# Marion County Development Review Committee Meeting Agenda

#### Monday, May 3, 2021

- 1. ROLL CALL
- 2. PLEDGE OF ALLEGIANCE
- 3. ADOPT THE FOLLOWING MINUTES: None
- 4. PUBLIC COMMENT
- 5. CONSENT AGENDA: STAFF HAS REVIEWED AND RECOMMENDS APPROVAL
  - 5.1. WEYBOURNE LANDING PHASE 1C FINAL PLAT 8575 SW 80TH ST OCALA Project #2020110028 #25962 Parcel #35300-000-17 JCH Consulting Group
  - 5.2. HAMMOCK LANE NORTH AGRICULTURAL LOT SPLIT 13005 NW 32ND CT REDDICK Project #2021030030 #26408 Parcel #07244-000-01 Rogers Engineering

S:\Marion County\Golden Ocala Equestrian Center (2017)\CIVIL\CONSTRUCTION\06 Site Grading Plan.dwg, 06.11 10 Site Grading Plan, 3/2/2021 2:27:45 PM, 1:1

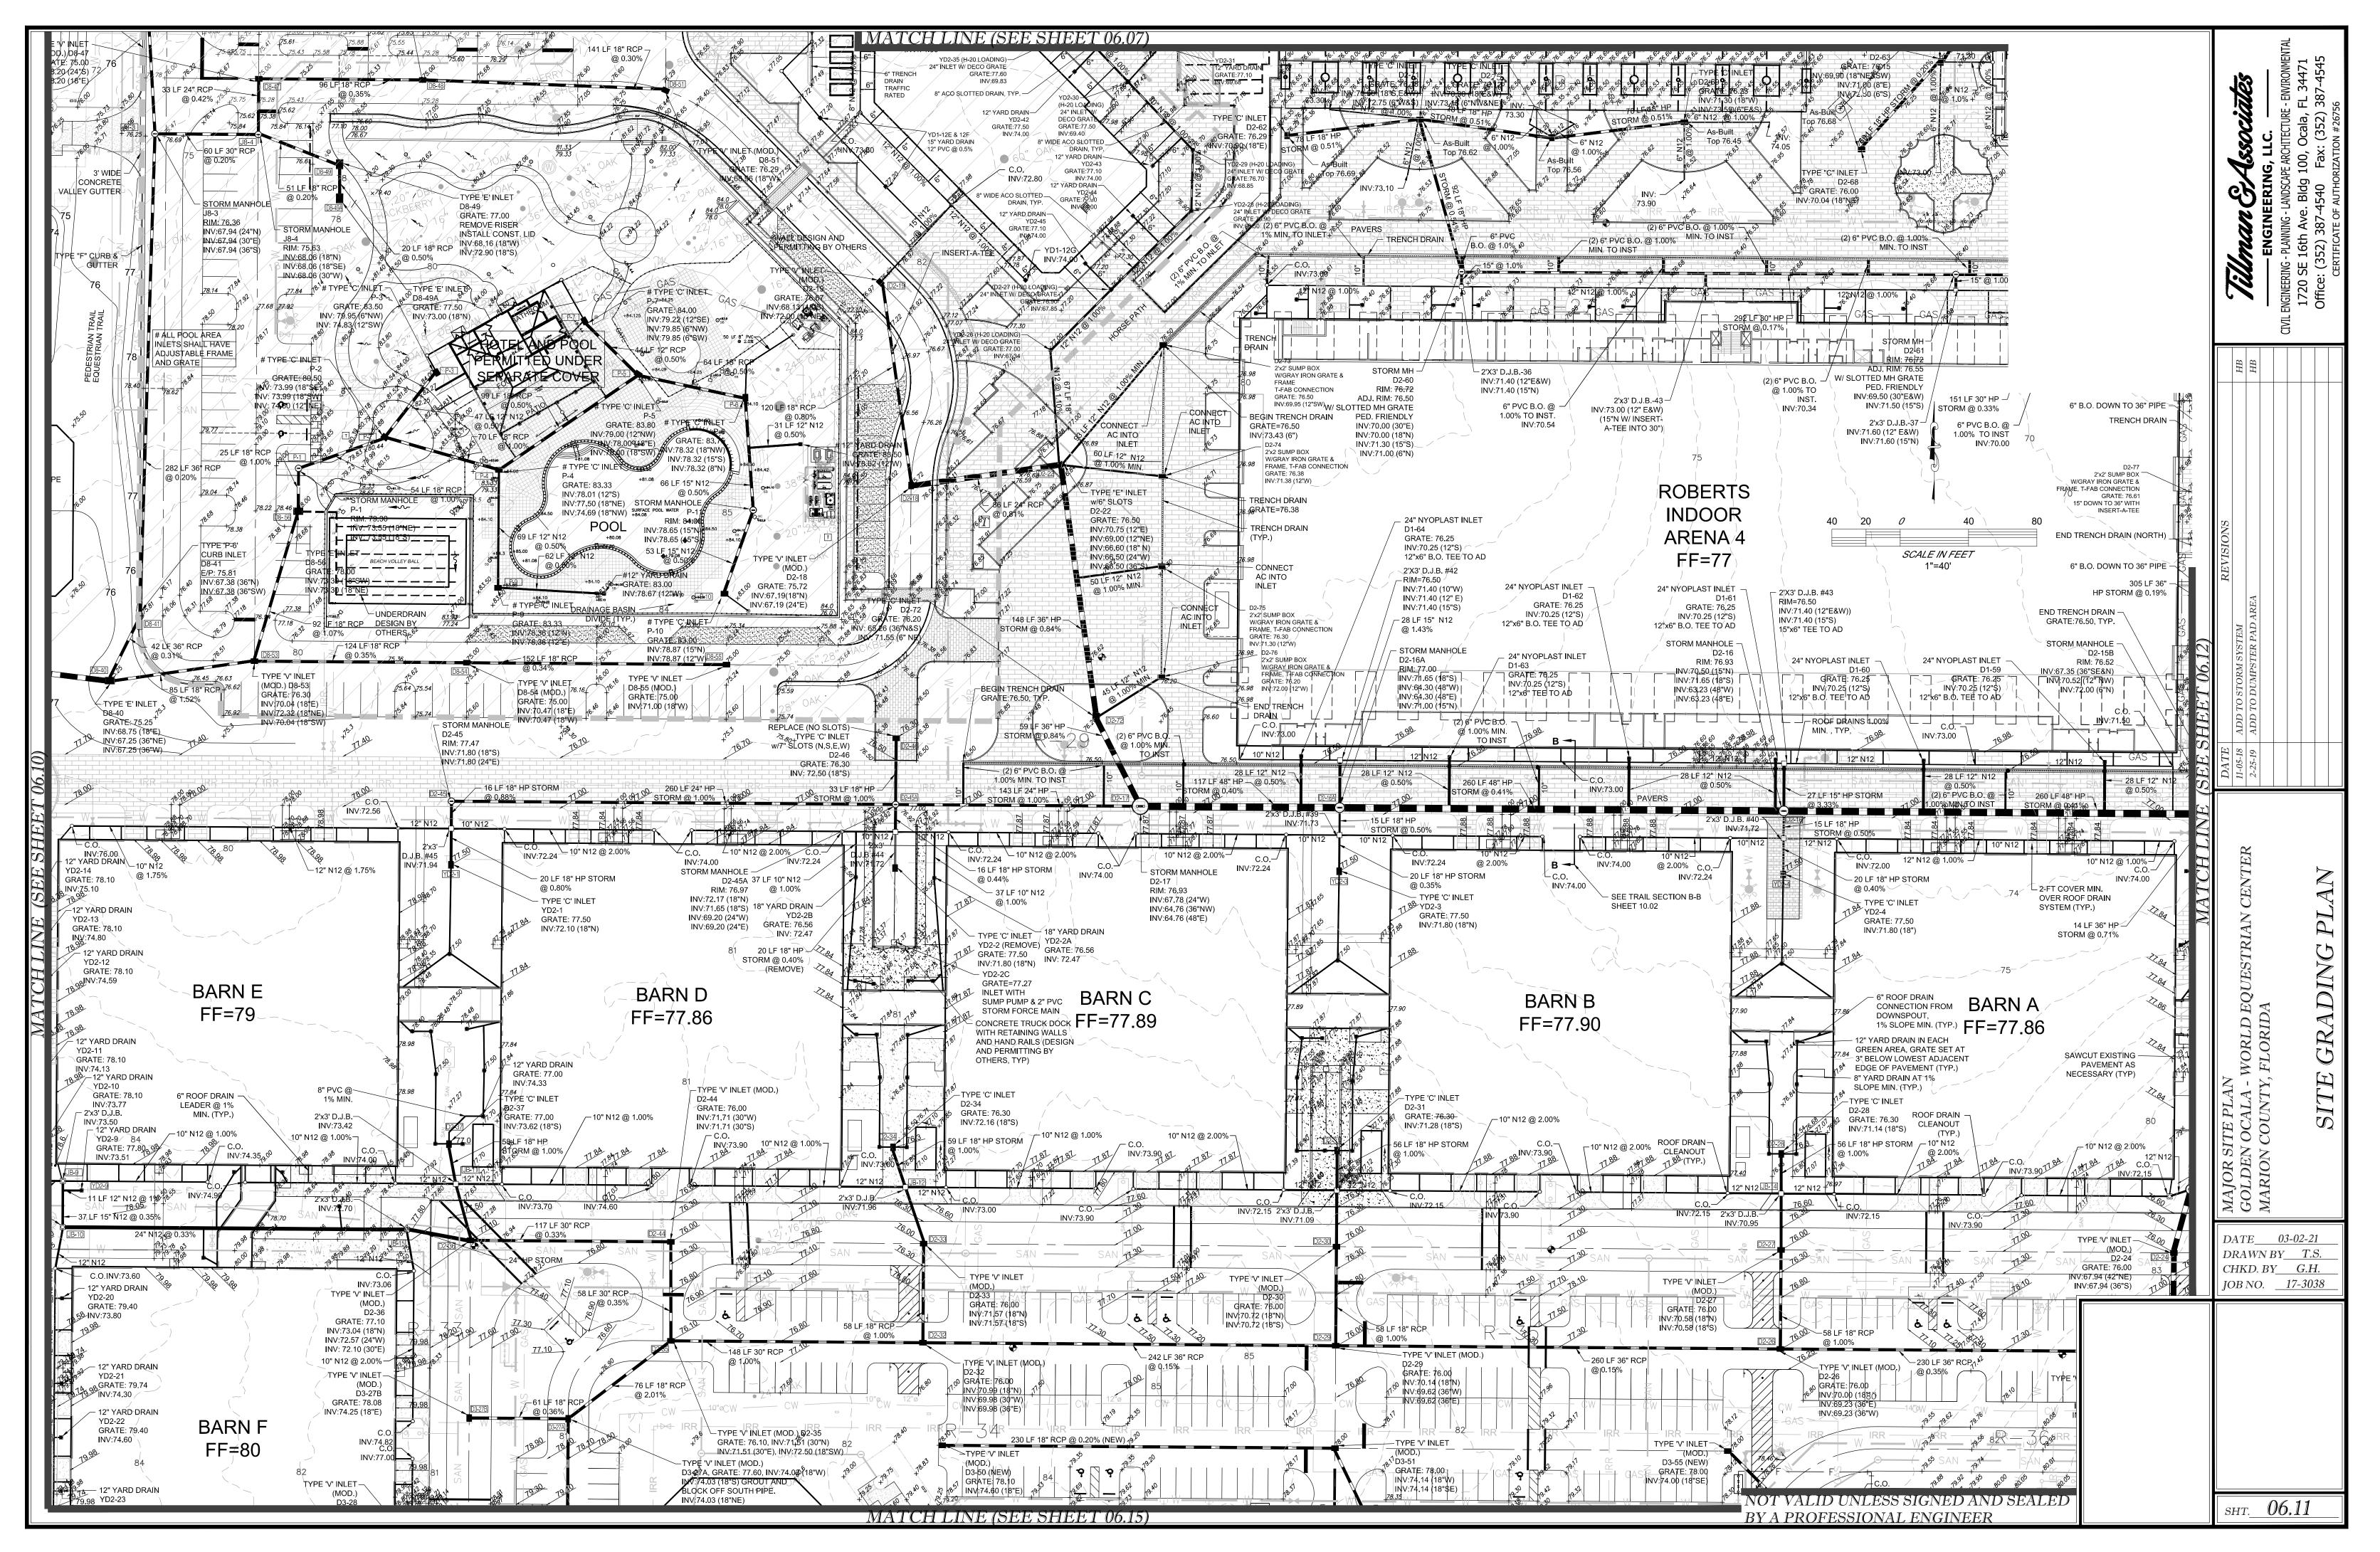
Revision to sheet 06.11 (site grading plan).

7.3.2 UT 208			SHT. 07.01

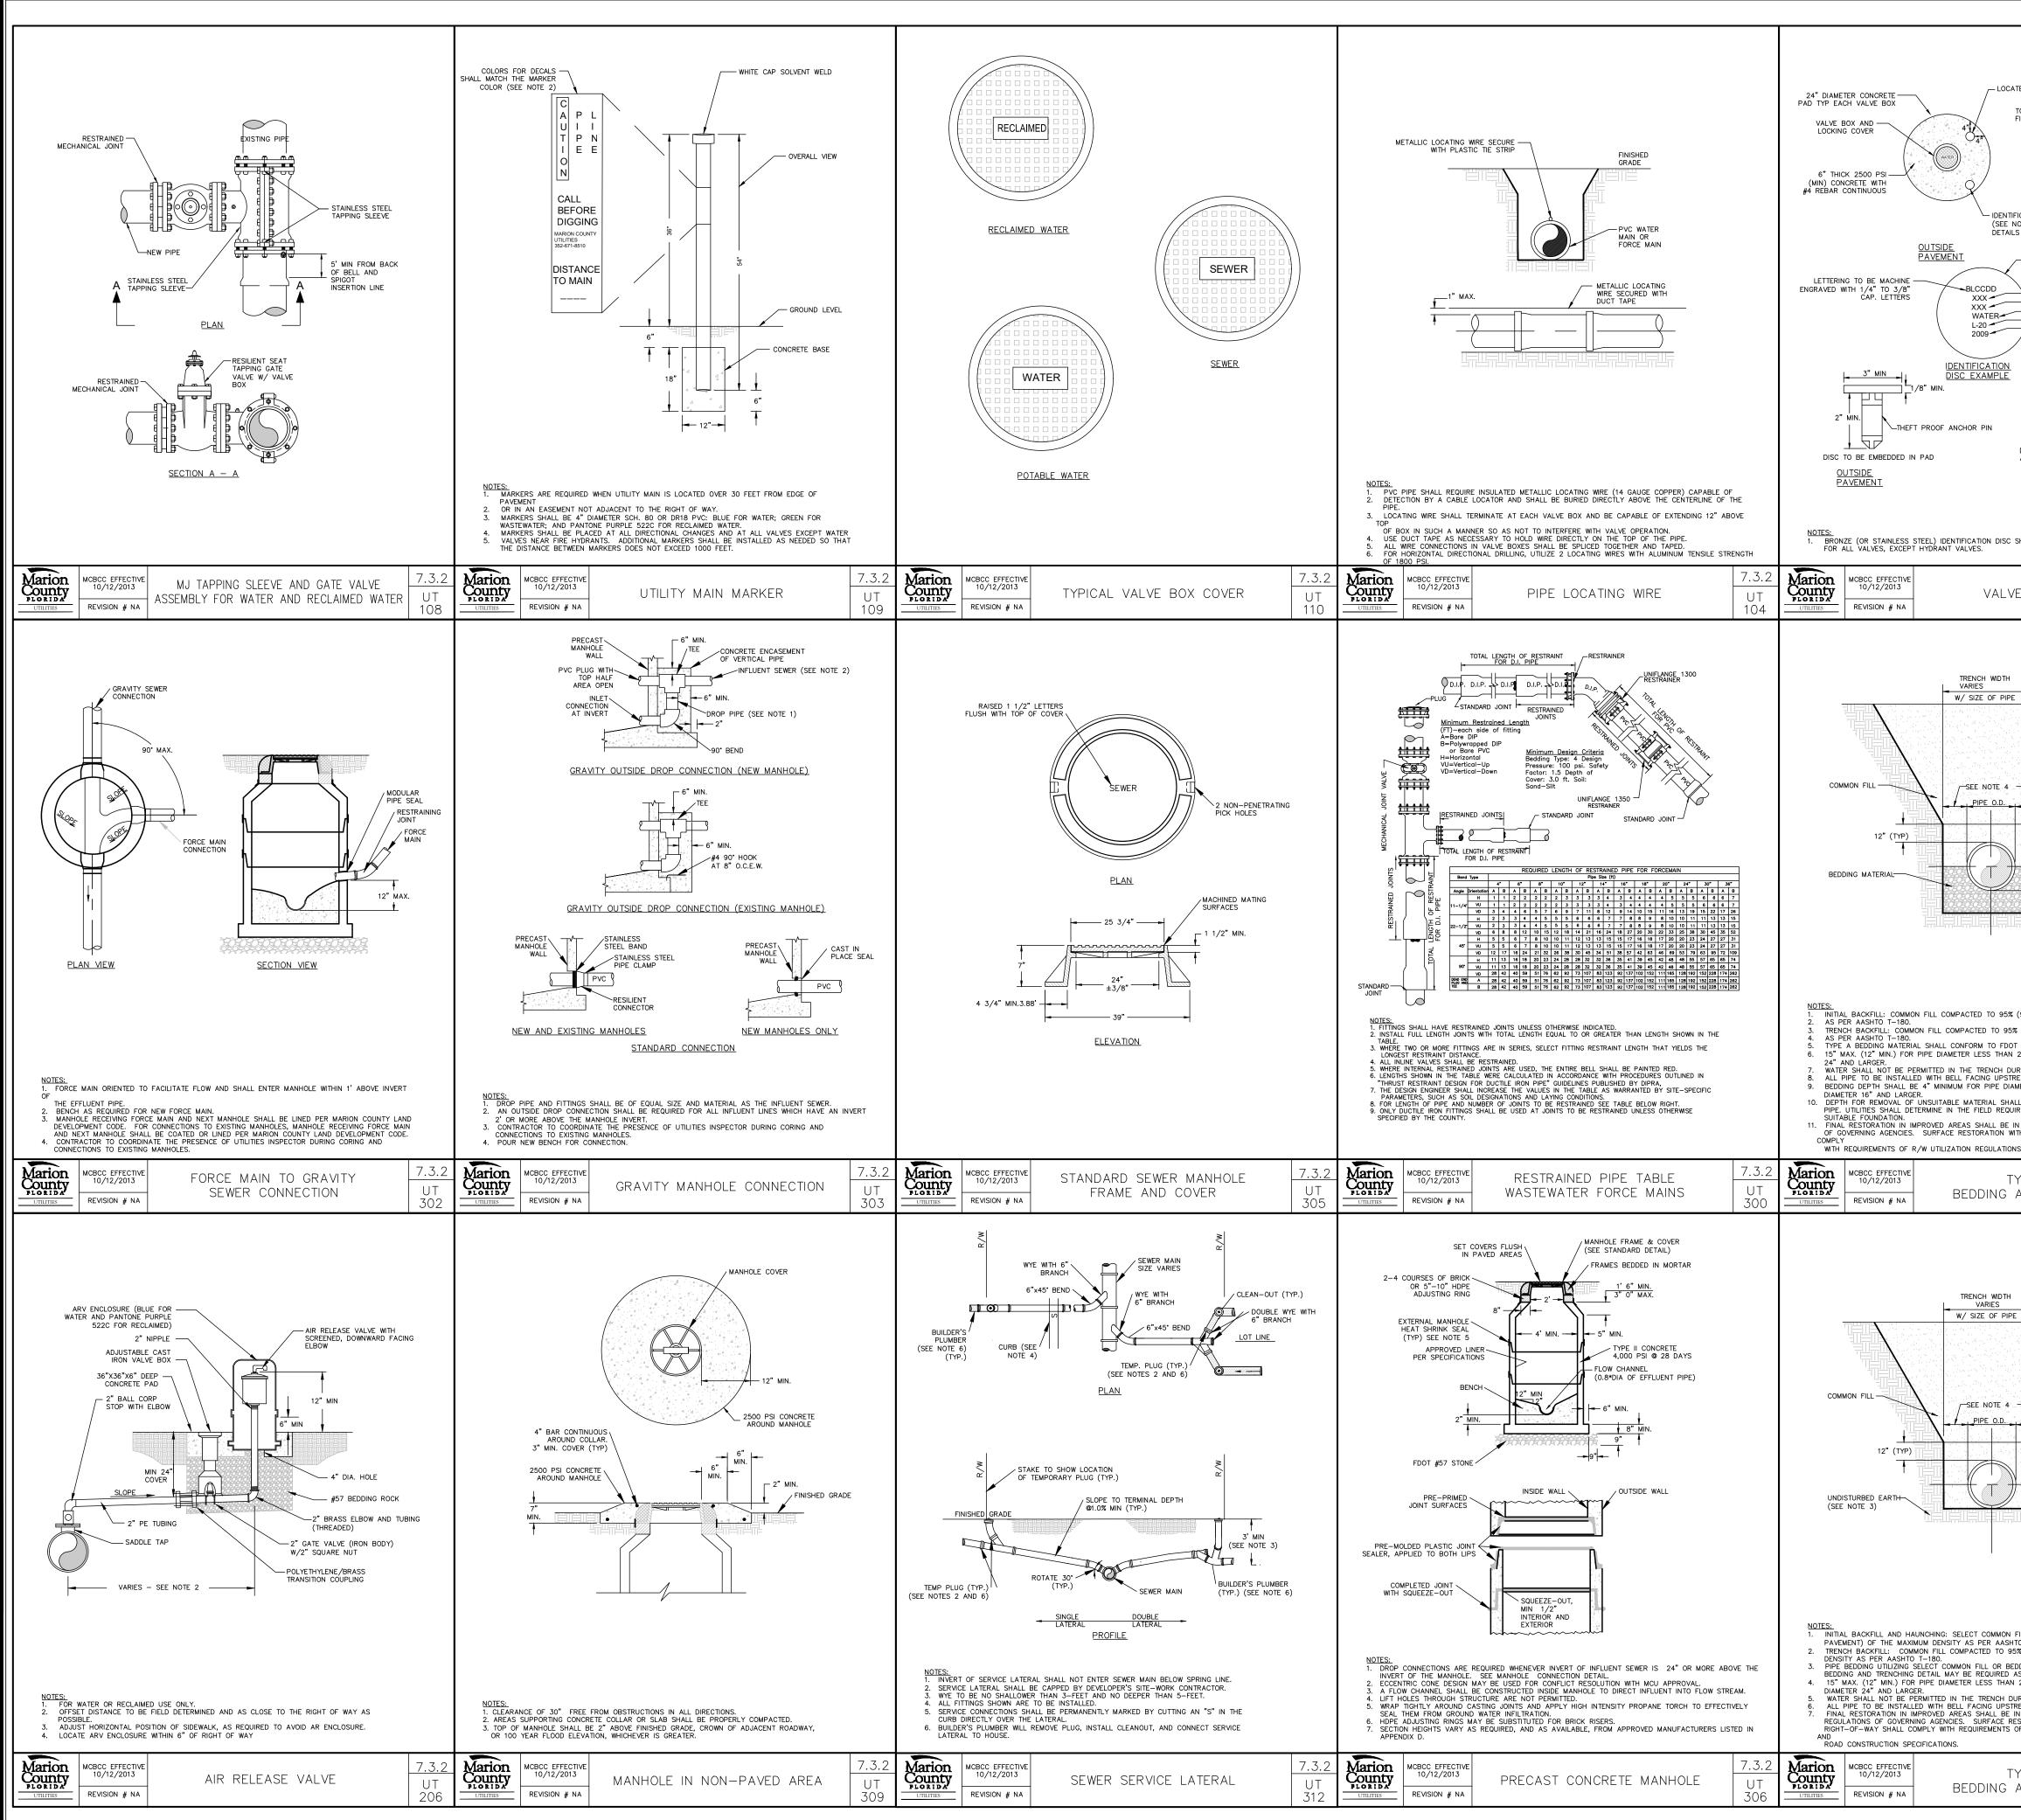
- DEPARTMENT: ENGDRN STORMWATER REVIEW REVIEW ITEM: 6.13.2.A(5) - Existing/Proposed Stormwater Structures STATUS OF REVIEW: NO REMARKS: 1) Please provide specify the type of yard drain and grate to be used. Provide a detail or a reference to a detail. 2) Please specify trench drain to be used. Provide a detail or reference to a detail.
- DEPARTMENT: ENGDRN STORMWATER REVIEW REVIEW ITEM: 6.13.2.A(7) - Existing/Proposed Stormwater Swales STATUS OF REVIEW: NO REMARKS: Please provide a typical swale detail for the swales shown on plan. Please show as sodded.
- DEPARTMENT: ENGDRN STORMWATER REVIEW REVIEW ITEM: 6.13.2.A(12)/6.12.5 - Stormwater Details, Cross Sections, References STATUS OF REVIEW: NO REMARKS: It appears Detail Sheet 12.01 was not uploaded. Please upload.
